Statement on UNECE Regulation No. 131 concerning advanced emergency braking systems (AEBS) in goods road transport vehicles and buses

(As at 30/08/2021)

Comments and recommendations from the DVR for current changes to UNECE Regulation No. 131

Figure 1:

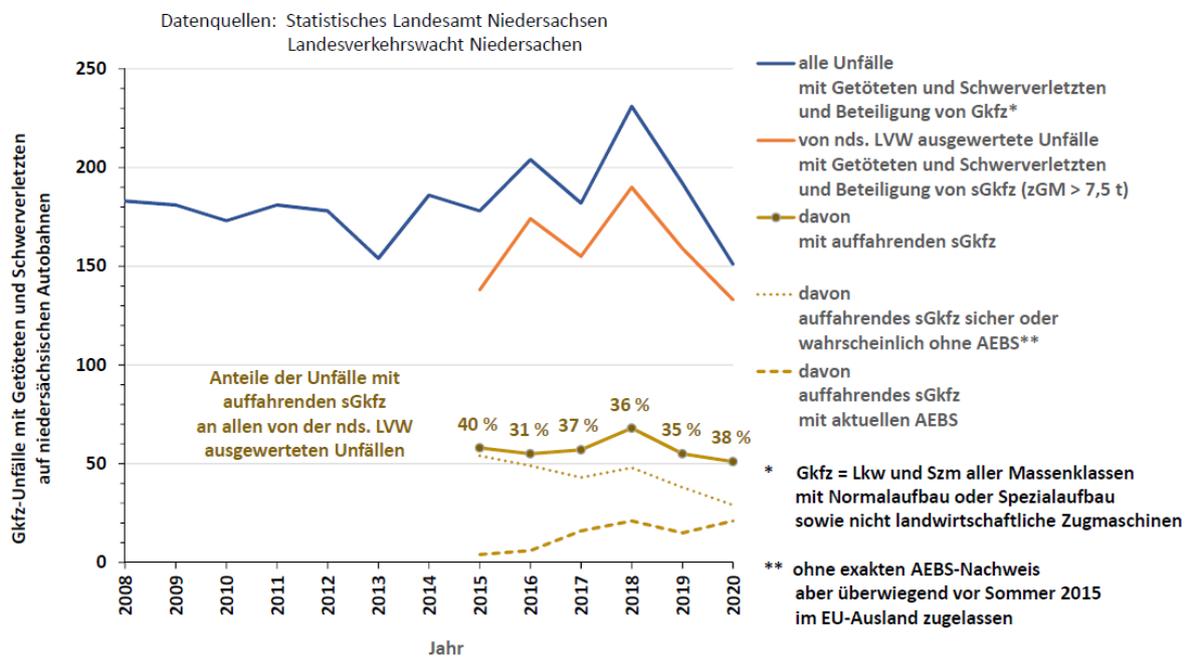
The percentage of forward collisions involving vehicles with AEBS functionality increased from 11% in 2016 to 35% in 2020 as more vehicles were equipped with AEBS; see Figure 1. This includes one to four deaths and seven to 24 serious injuries.
